# Ground Gas Verification Report

## Public Open Space, Wygate Park, Spalding

**BRD241183-OR14-A**

**November 2020**

**Photo 3 and 4** – Tape seal ran over at fold in membrane creating air gap along fold and repaired defect. Note that Photo 3 (left) shows the defect after it had been opened up by the verifier to make it more obvious where repair was required.

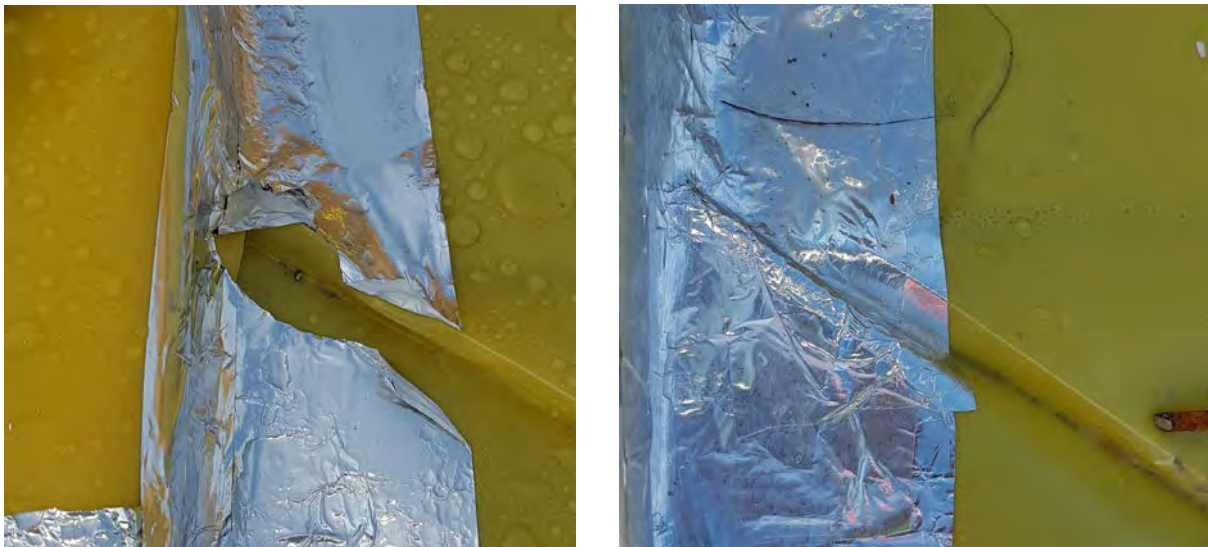
**Photos 1 and 2** – Gap in sealing around ‘top hat’ found on Plot 904 and remedied.
